CALL NO. 103
CONTRACT ID NO. 181025
ADDENDUM # 3

Subject: BOONE COUNTY, STP 8200(017)
Letting July 27, 2018

- (1) Revised - Proposal Bid Items - Pages 237-243 of 243
- (3) Revised - Plan Sheets - R2g, T13, T14, and T16

REVISED 7-25-18

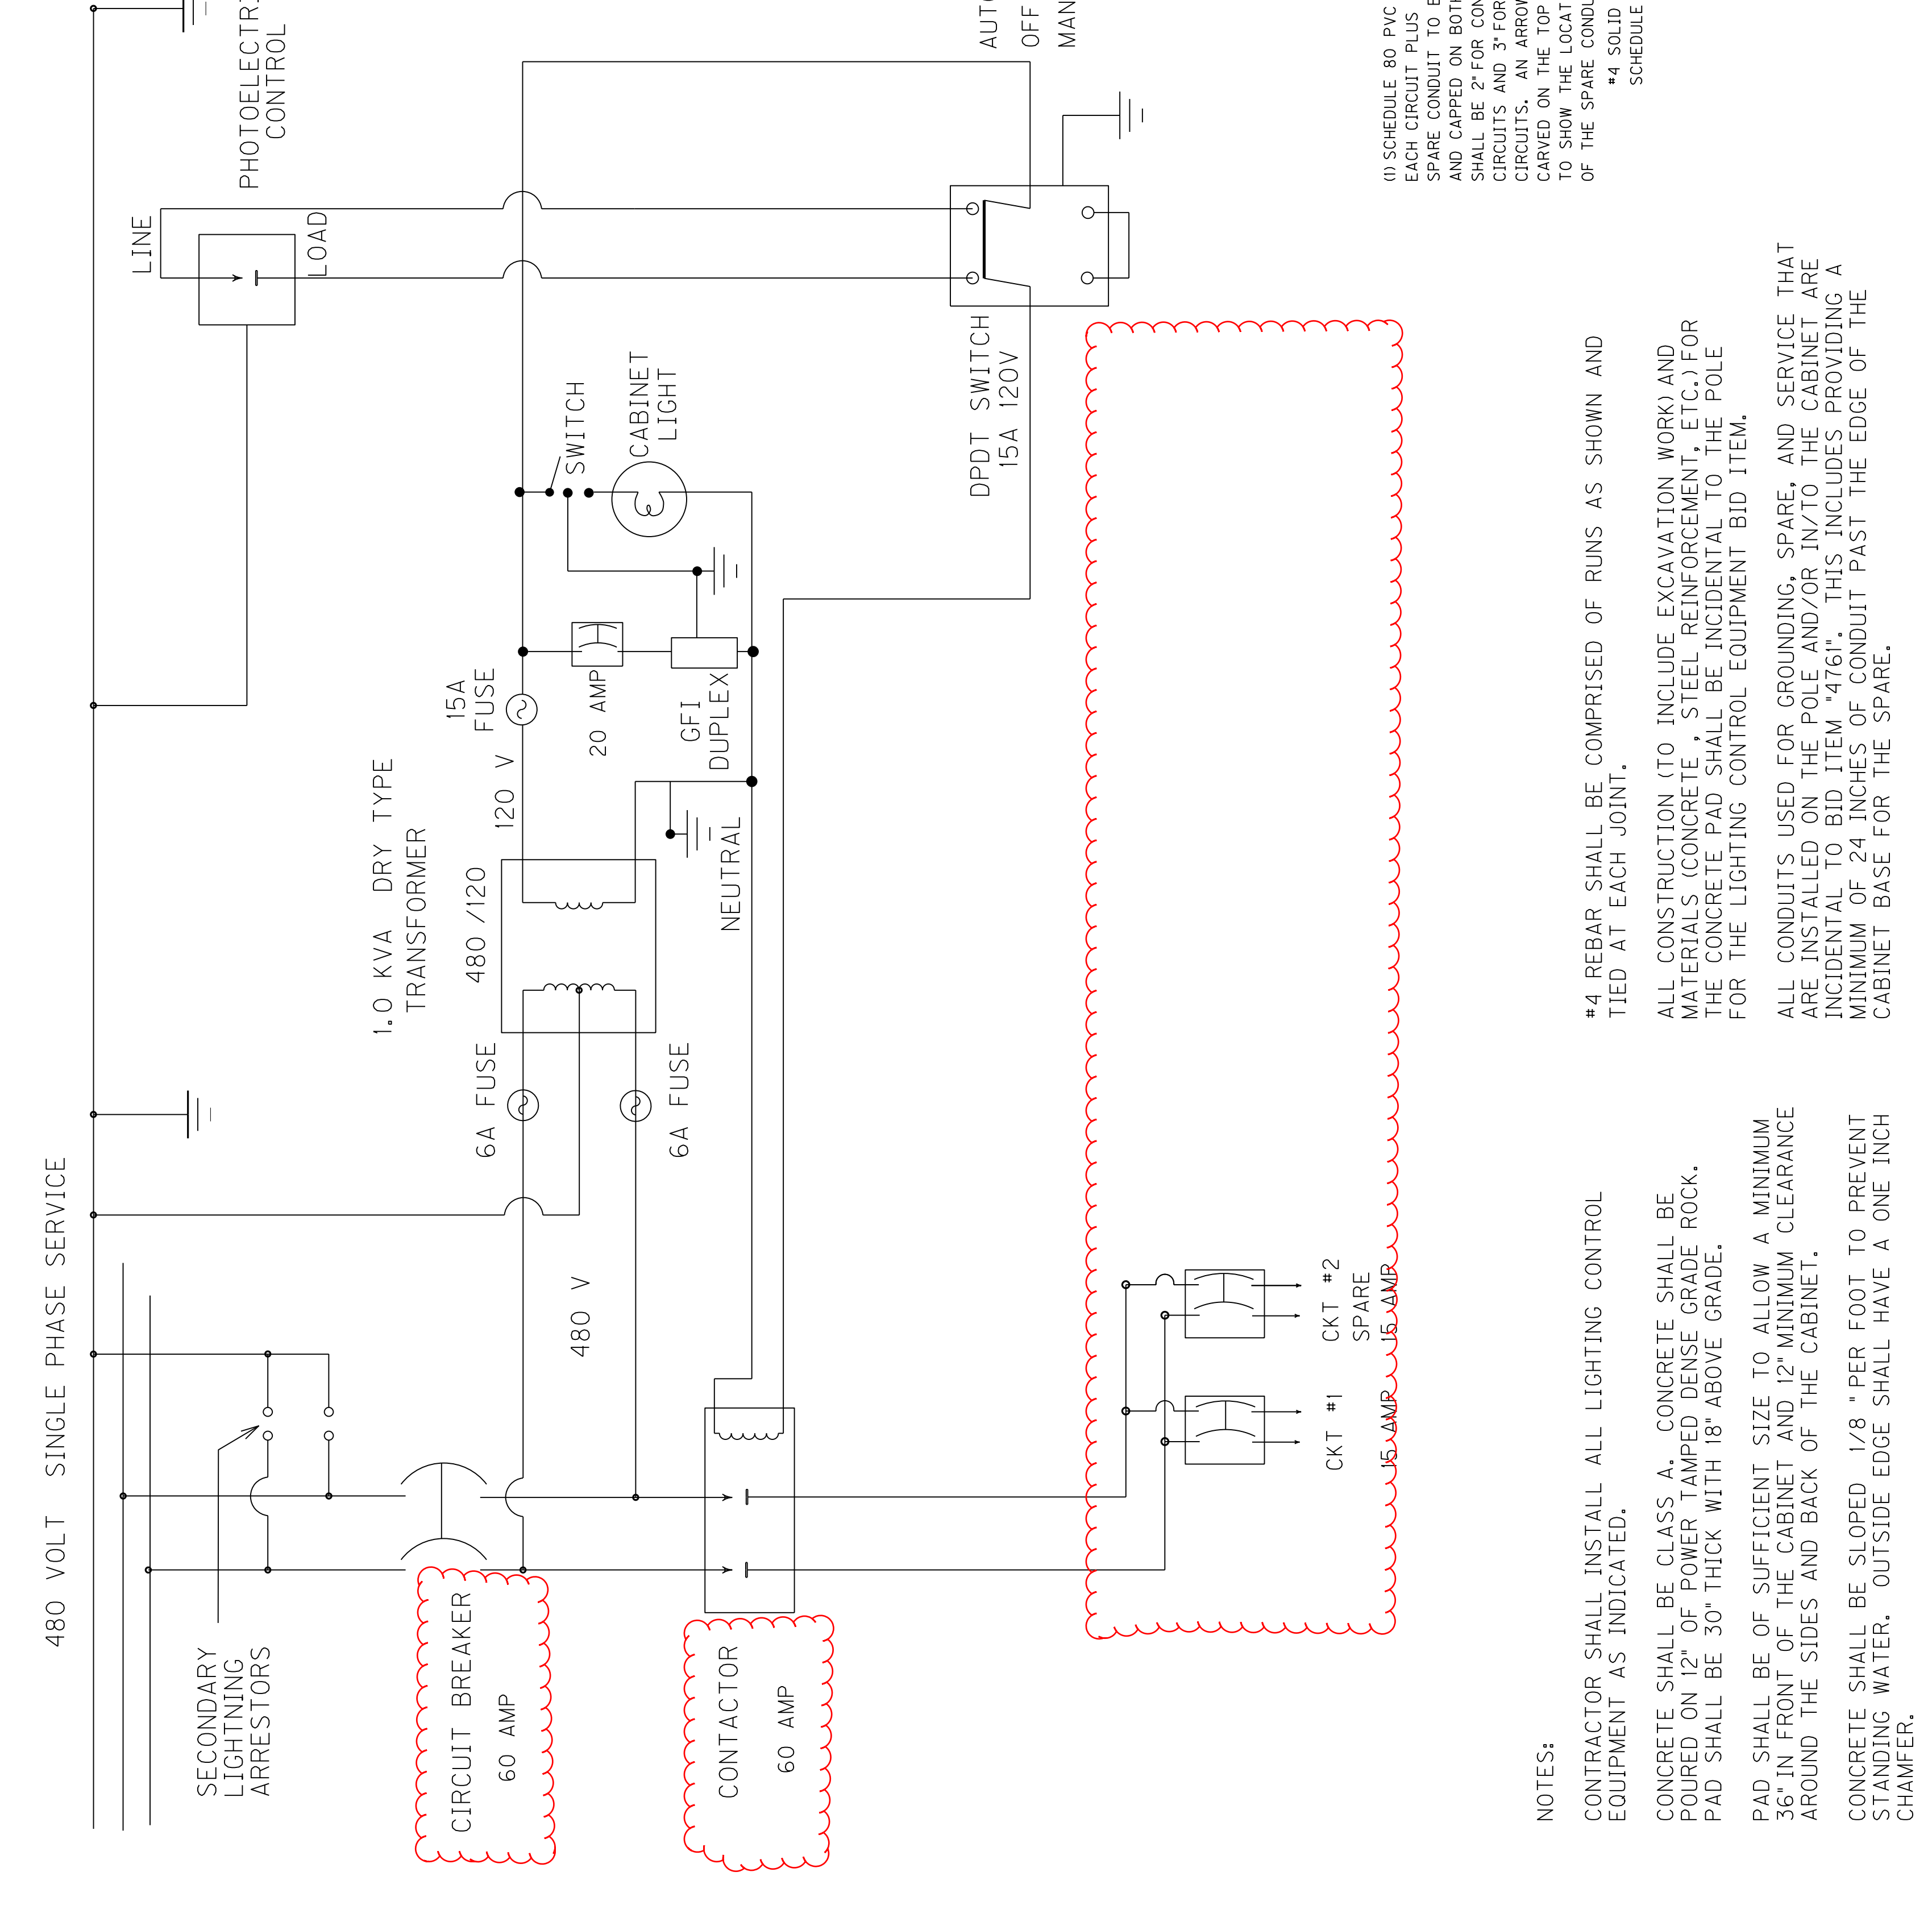
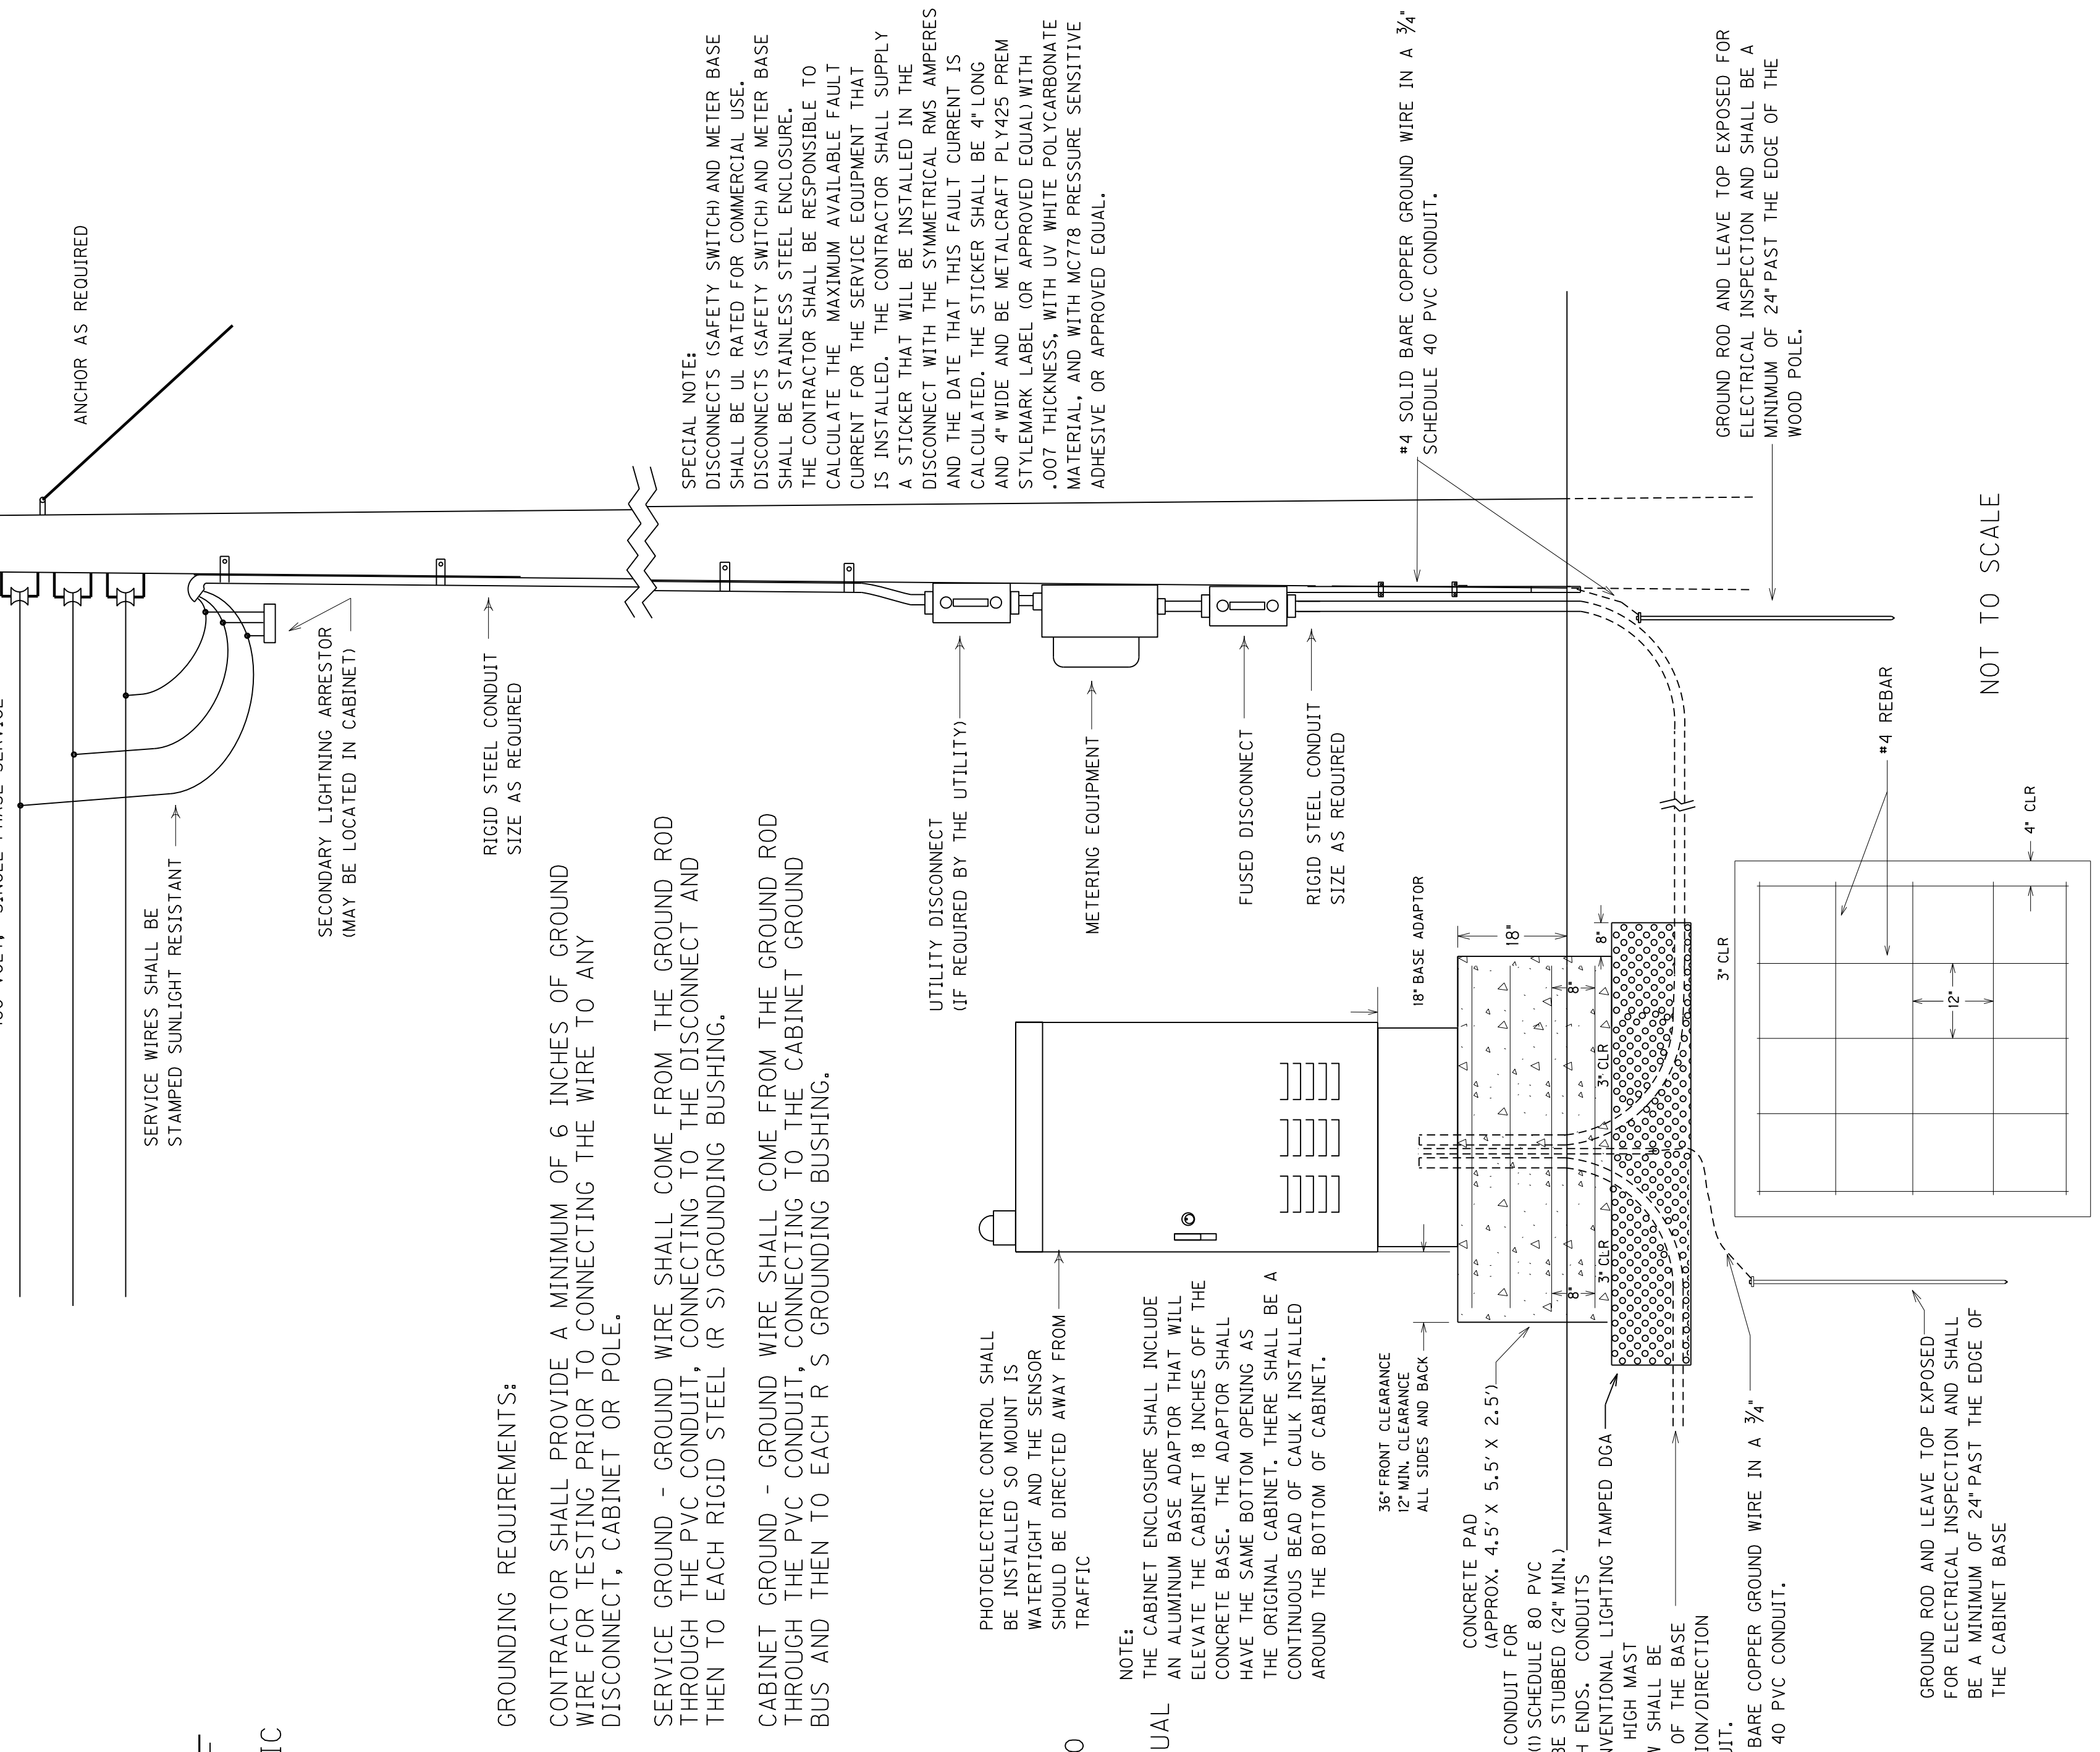
NOTE:
THE CABINET ENCLOSURE SHALL INCLUDE AN ALUMINUM BASE ADAPTOR THAT WILL ELEVATE THE CABINET 18 INCHES OFF THE CONCRETE BASE. THE ADAPTOR SHALL HAVE THE SAME BOTTOM OPENING AS THE ORIGINAL CABINET. THERE SHALL BE A CONTINUOUS BEAD OF CAULK INSTALLED AROUND THE BOTTOM OF CABINET.
